Agenda
Village of Arlington Heights
Design Commission
Community Room, 3rd Floor

STAFF DESIGN COMMISSION REPORT RE-REVIEW

Project Name: 13 E. Miner Street
Project Address: 13 E. Miner Street
Prepared By: Steve Hautzinger

DC Number: 15-097
Petitioner Name: Frank Panzarino
Petitioner Address: 904 S. Edgewood Lane
Mt. Prospect, IL 60056
Meeting Date: August 11, 2015
Re-Review Meeting Date: October 27, 2015

RIGHT ELEVATION

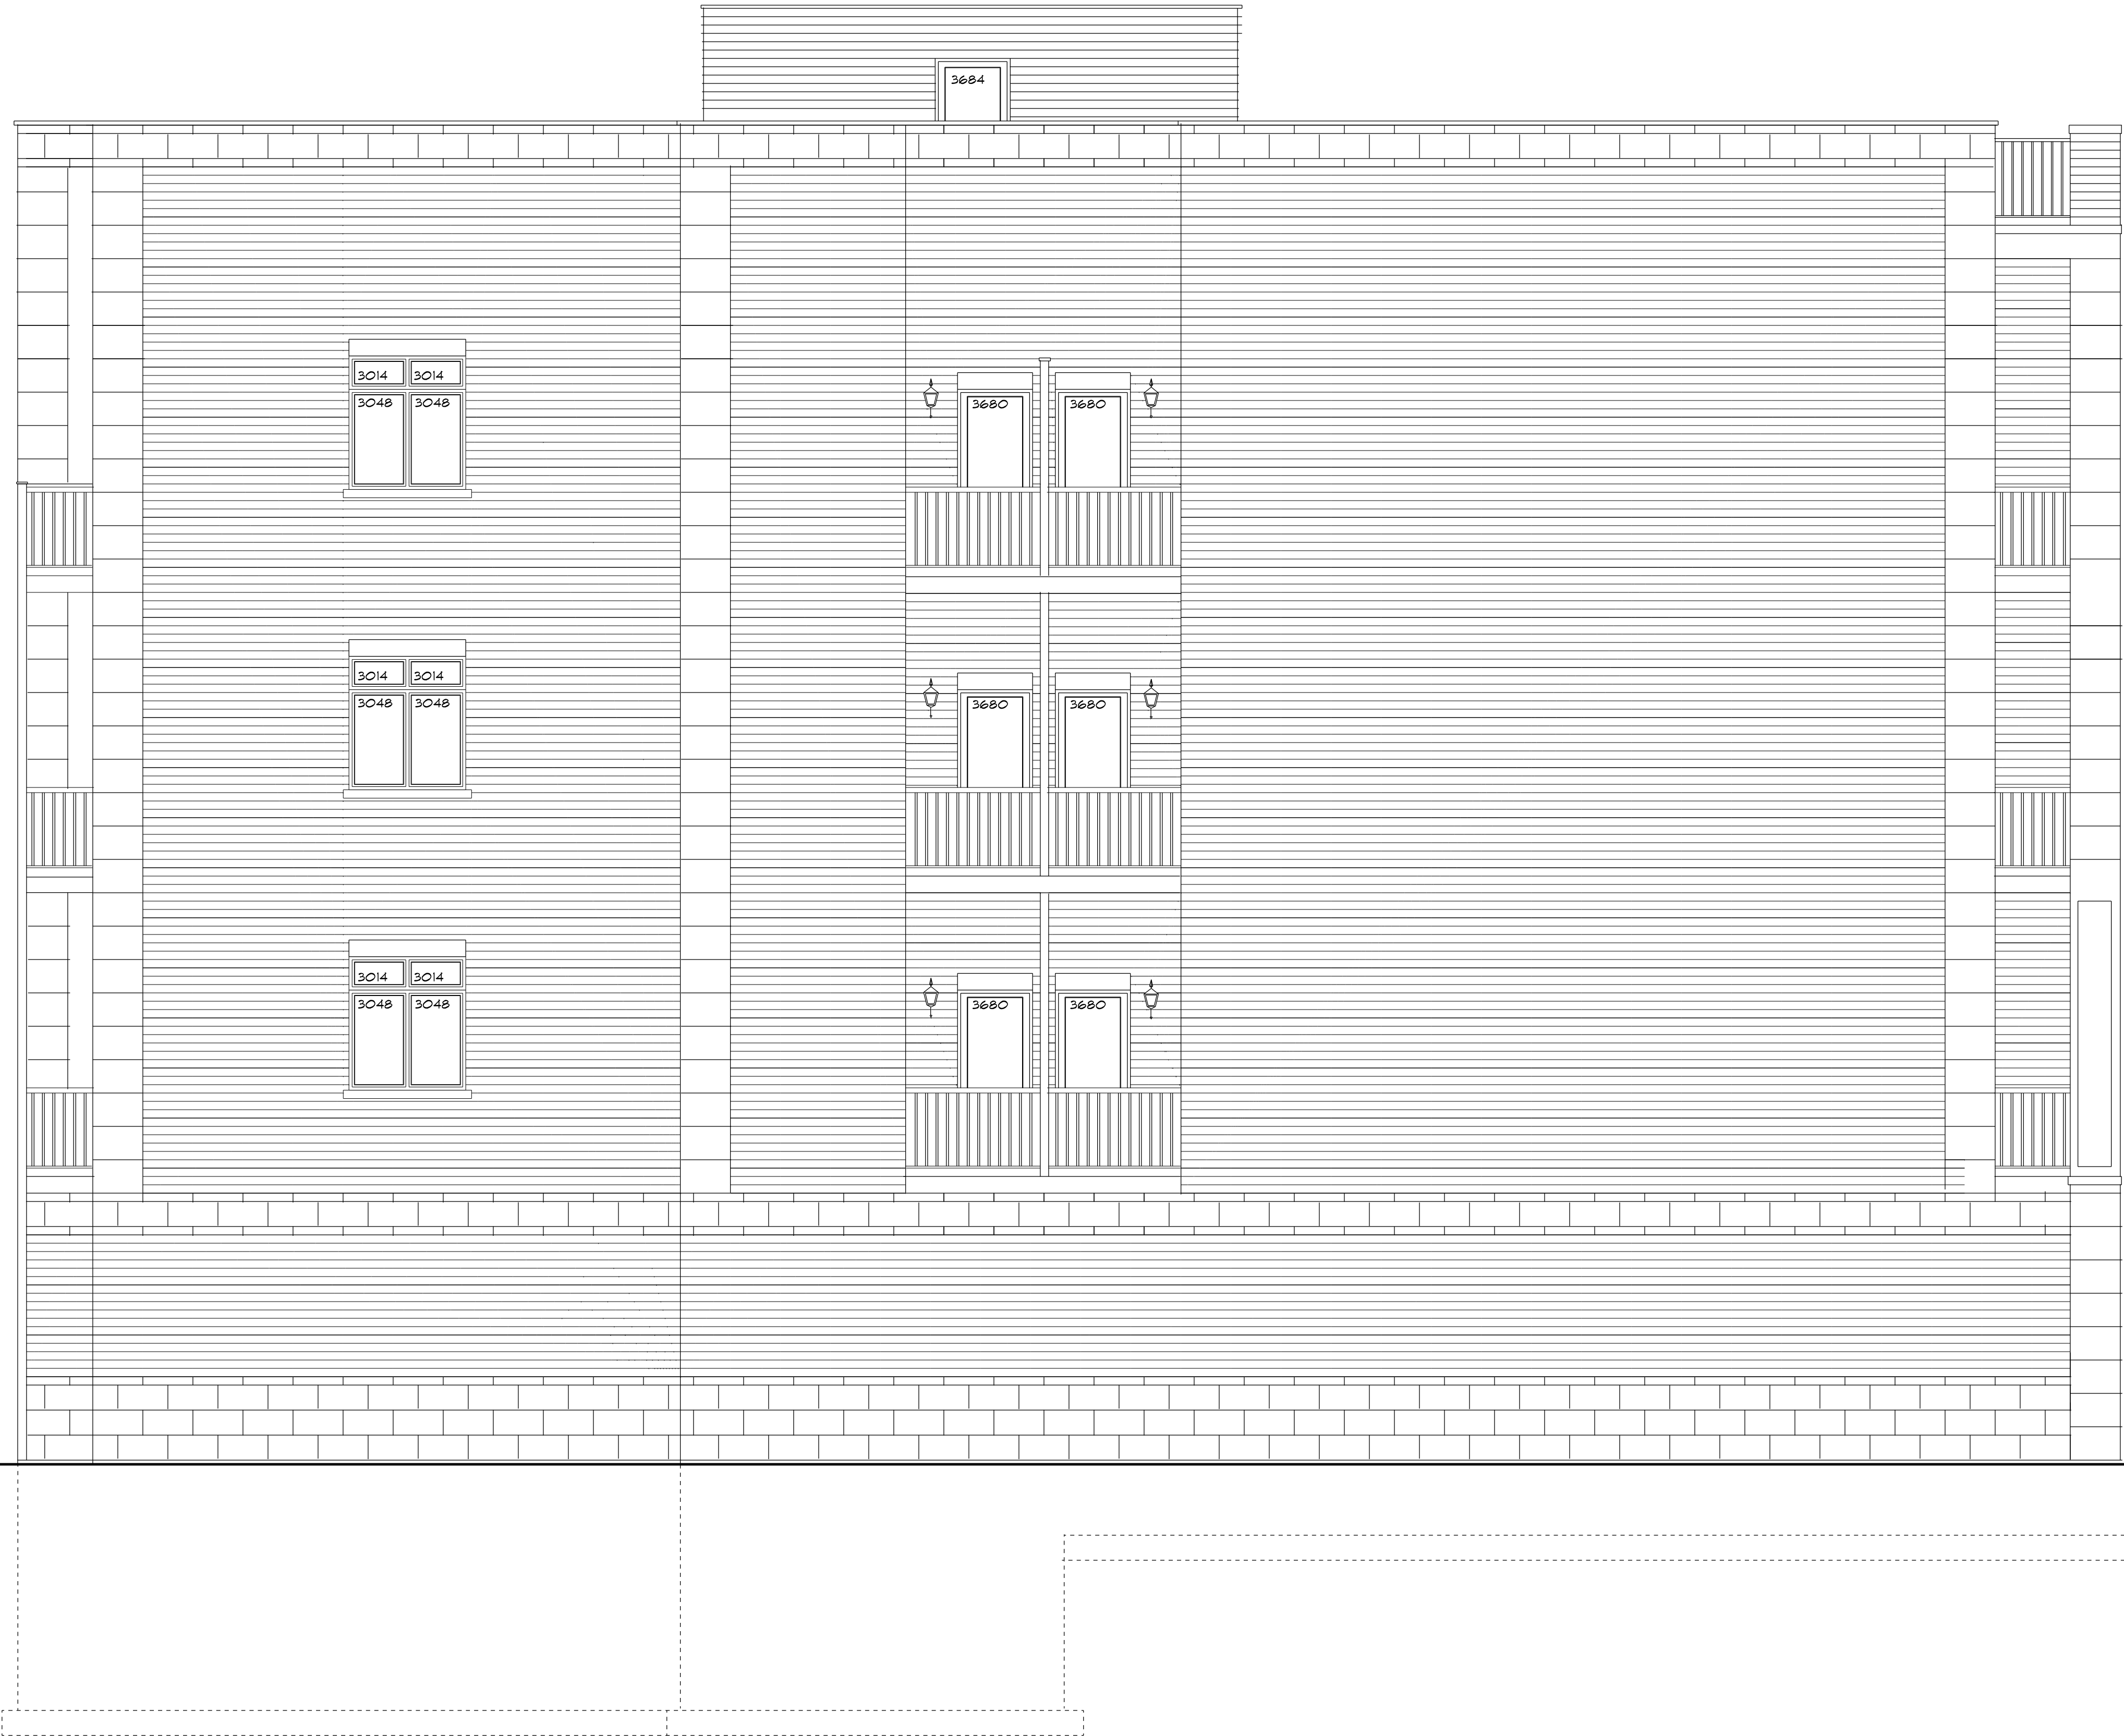
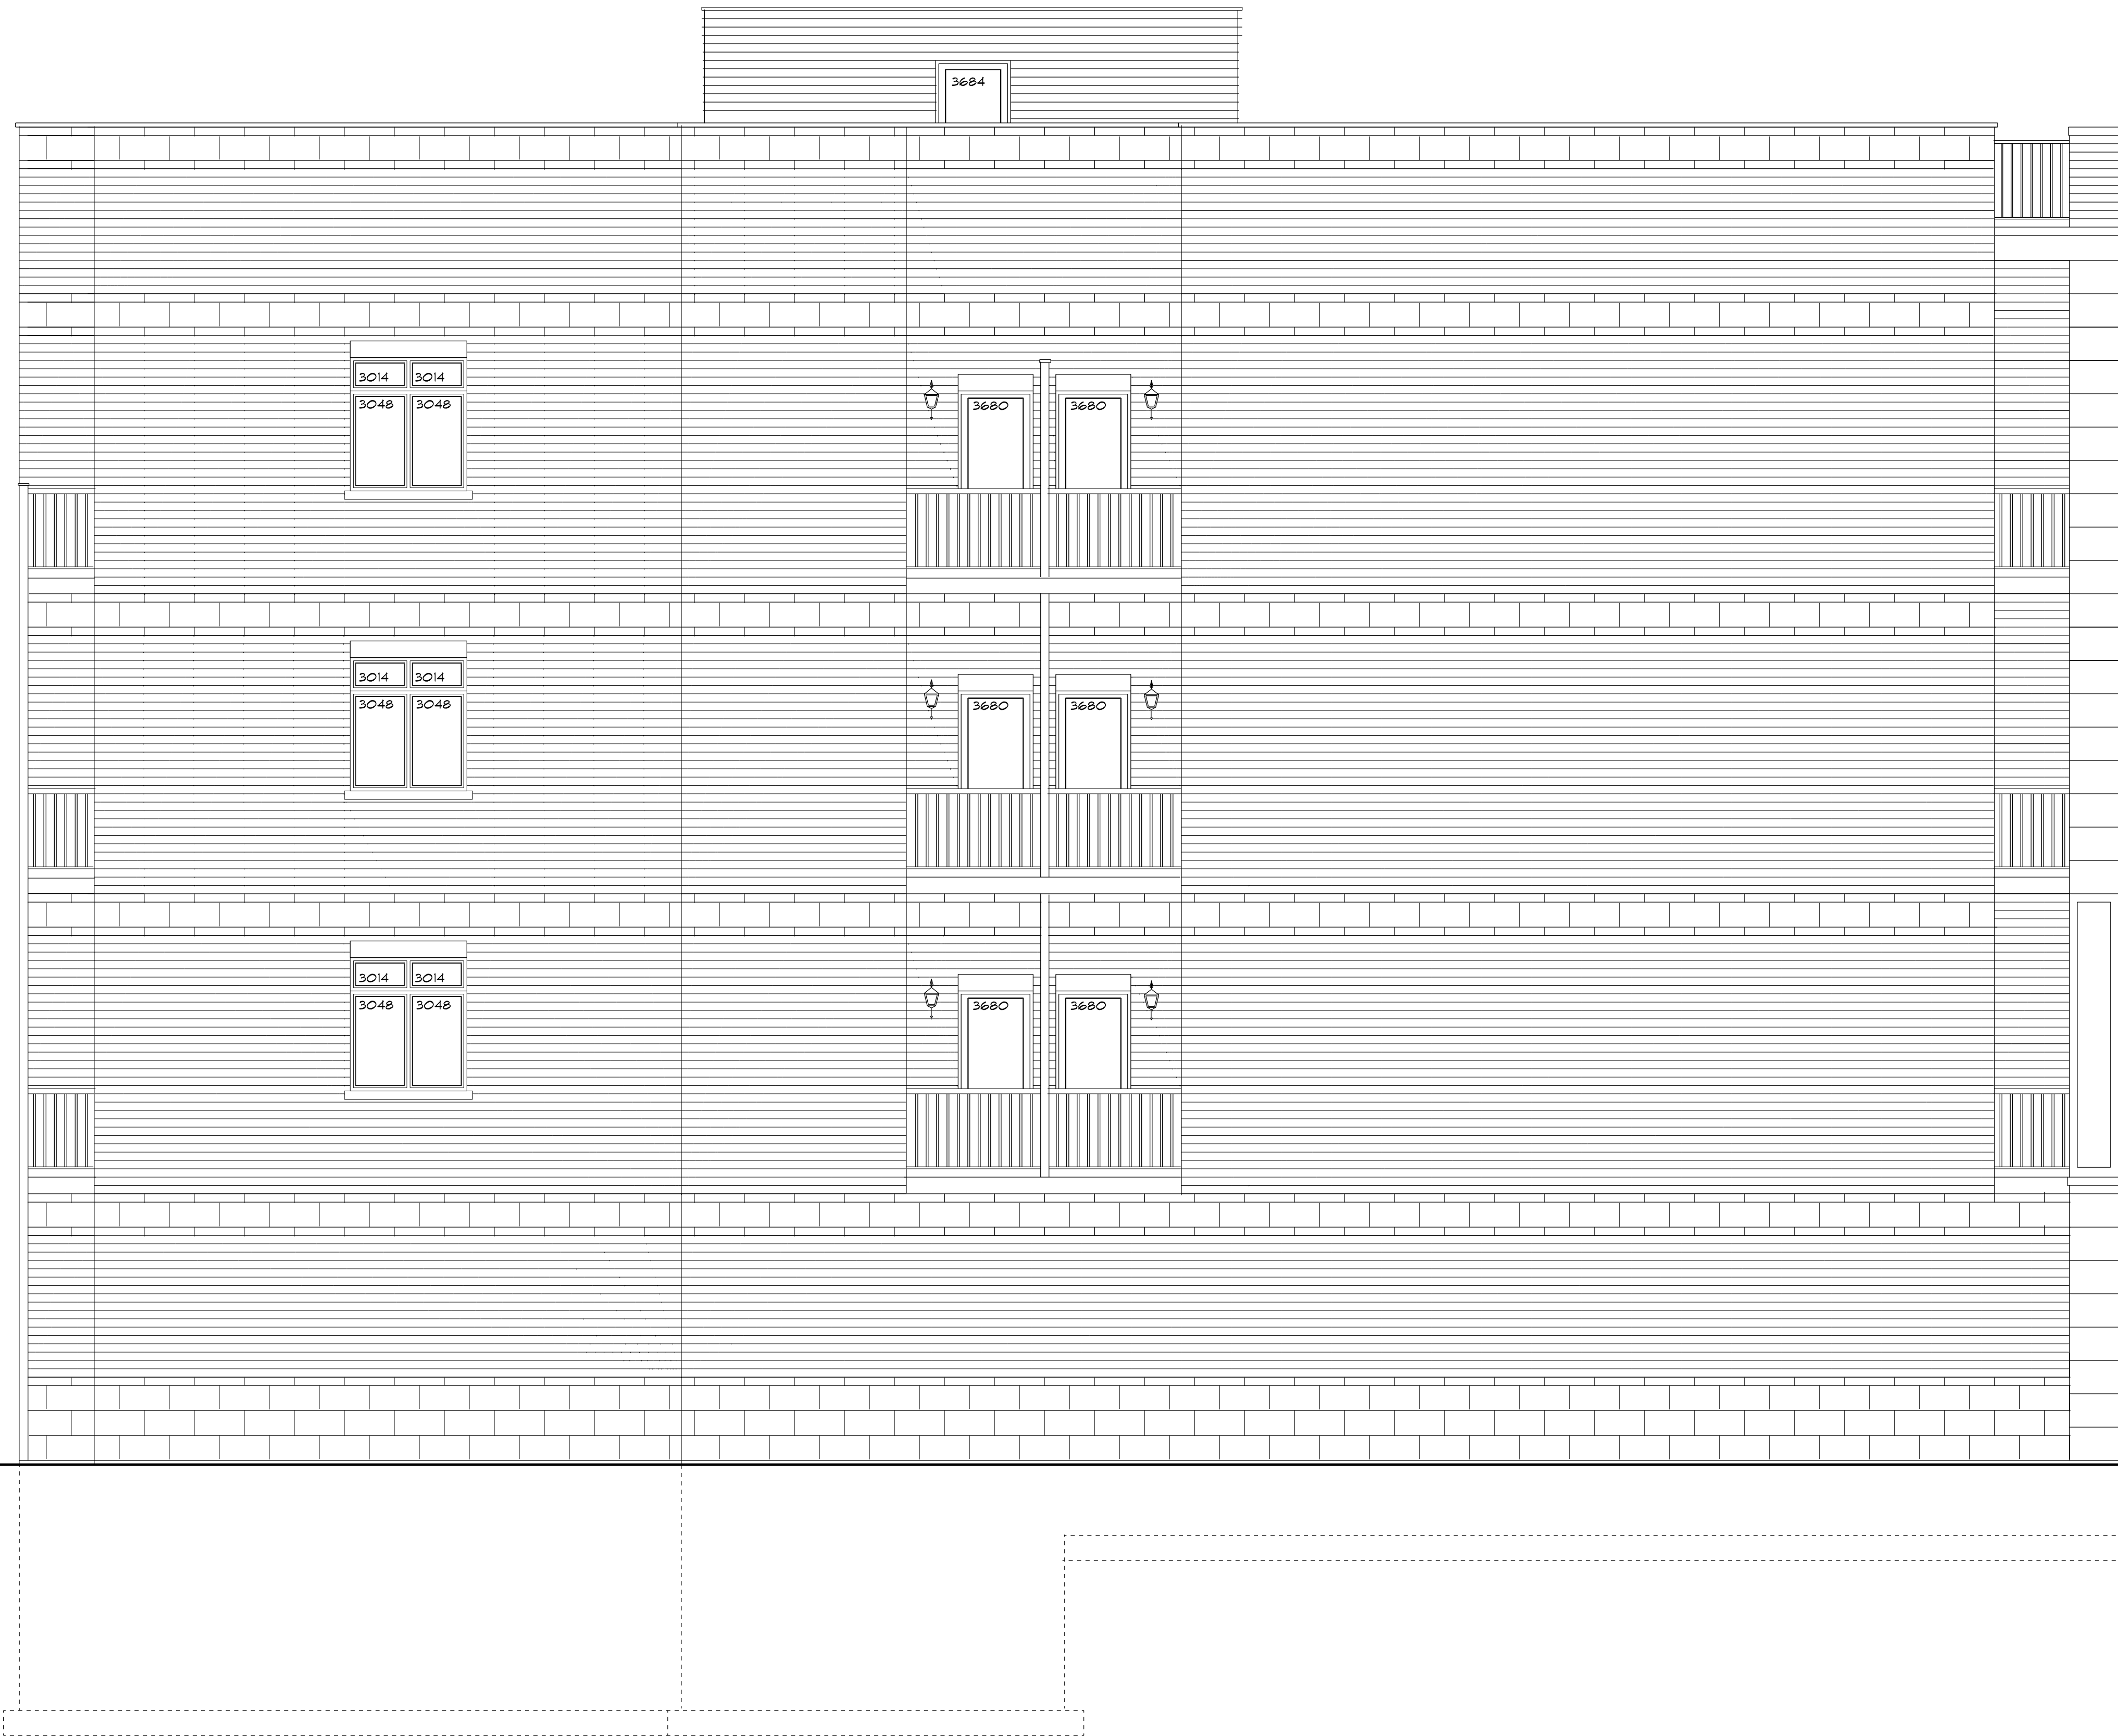
Side (east & west) Elevations. Both of the proposed options represent a good improvement from the original proposal with additional detailing that breaks up the large blank walls. However, the proposed horizontal banding option has very little relationship to the composition of the front elevation, so the option with vertical stacked stone quoins at the corners is preferred for a more cohesive design.

2. The stone base on the front end of the right elevation should be raised to match the detailing on the front elevation.

5. Change the rear patio doors to individual french doors.
6. The stone base on the front end of the right elevation should be raised to match the detailing on the front elevation.

SITE PLAN

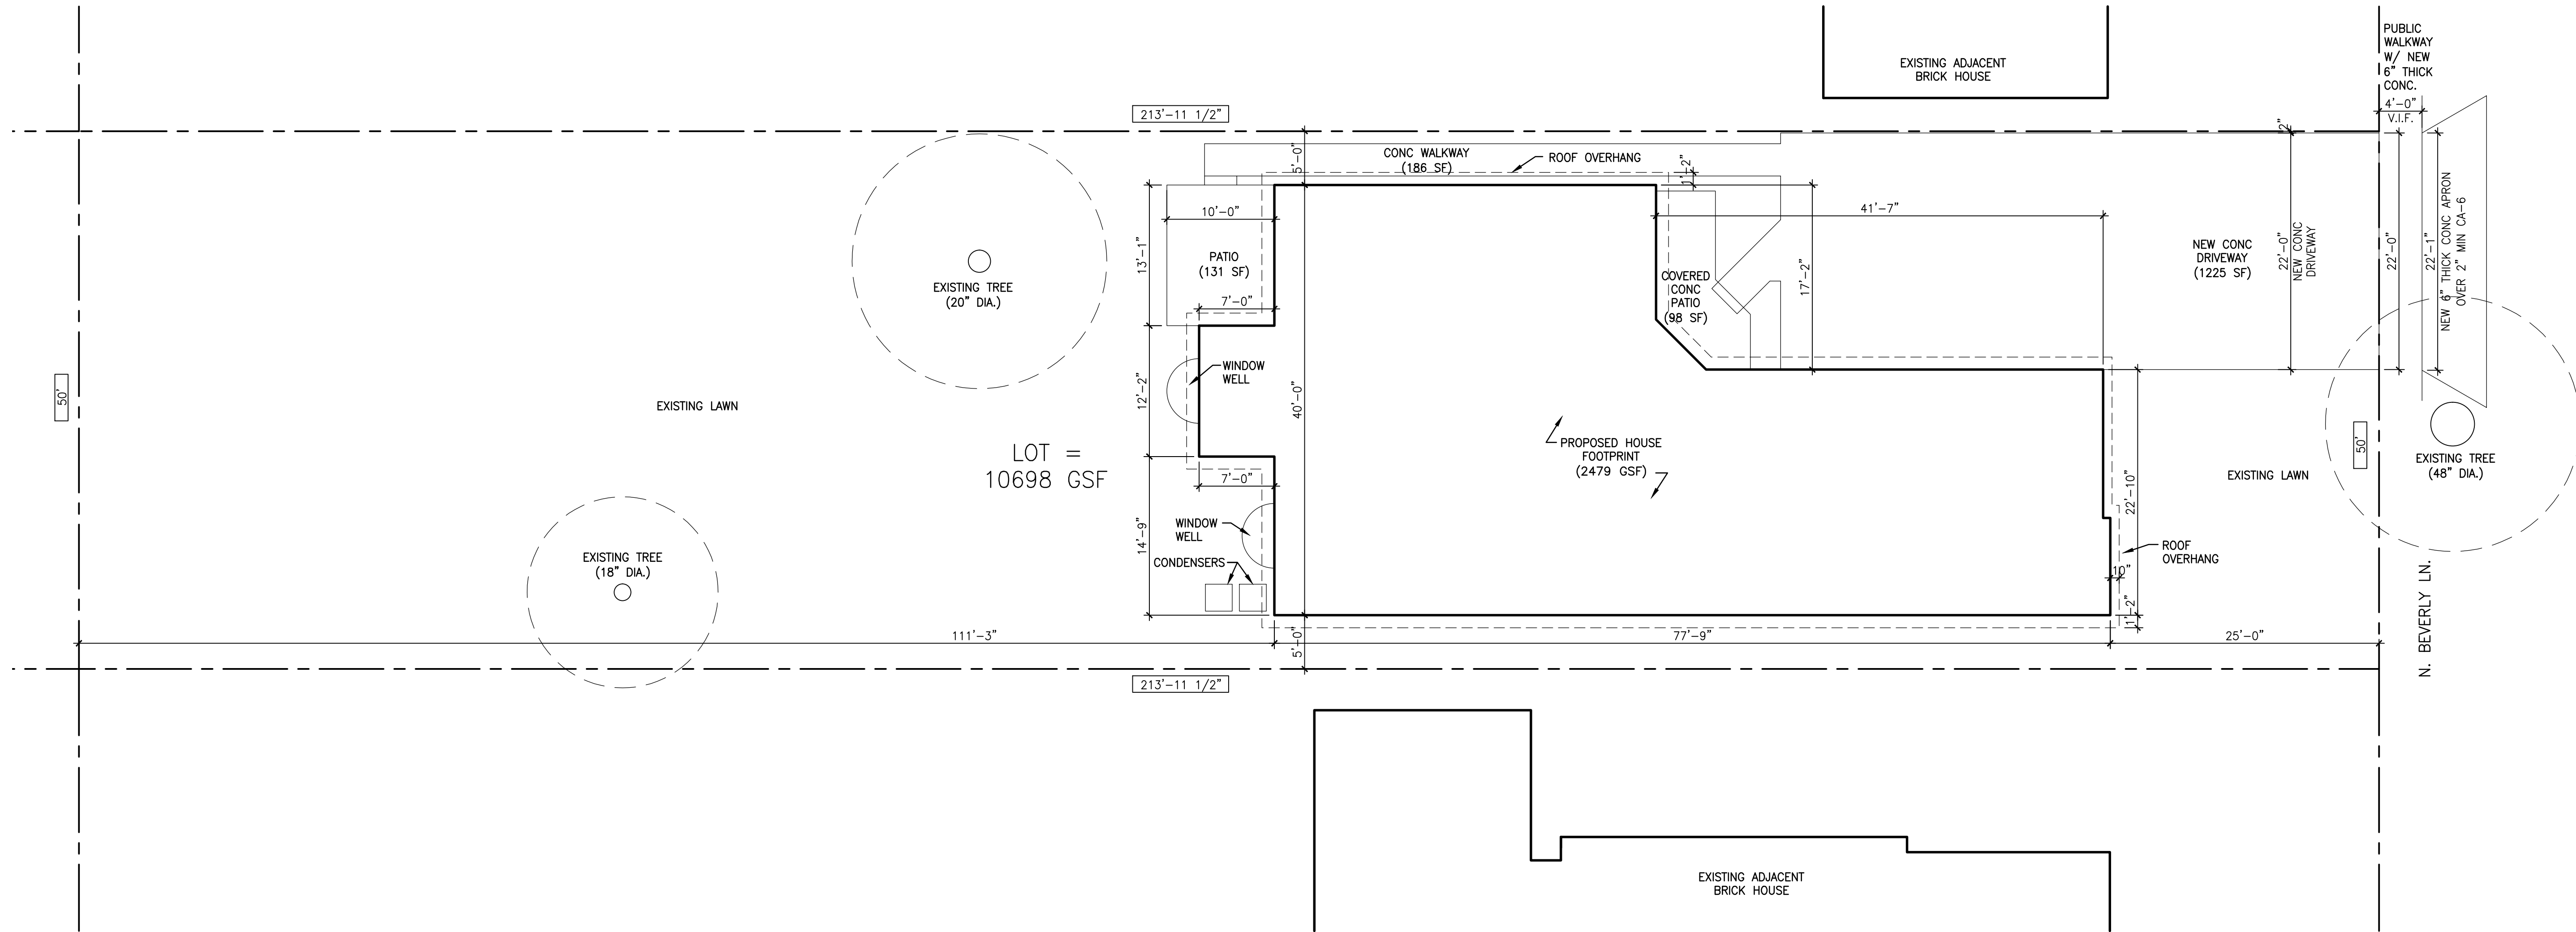
The proposed design includes an attached three car side load garage on the front of the house. The proposed garage pushes the main body of the house and front door away from the front of the site to the extent that the front door will be behind the back wall of the adjacent home to the north. This arrangement is not in context with the neighborhood, and is not in compliance with the Single Family Design Guidelines.

If a three car garage is desired, then the petitioner should consider a detached garage or an attached side load garage in the rear of the home. There is a nice example of a newer home across the street with a detached garage in the rear yard (refer to Image 1 below), and another example of a newer home with an attached side load garage in the rear (refer to Image 2 below). Both of these examples keep the main body of the house and front entrance in line with the rest of the block.

1. Revise the design to eliminate the three car side load garage on the front of the house to comply with the character of the neighborhood.
2. This review deals with architectural design only and should not be construed to be an approval of, or to have any other impact on, any other zoning and/or land use issues or decisions that stem from zoning, building, signage or any other reviews. In addition to the normal technical review, permit drawings will be reviewed for consistency with the Design Commission and any other Commission or Board approval conditions. It is the architect/homeowner/builder's responsibility to comply with the Design Commission approval and ensure that building permit plans comply with all zoning code, building permit and signage requirements.
3. Compliance with all applicable Federal, State, and Village codes, regulations and policies.
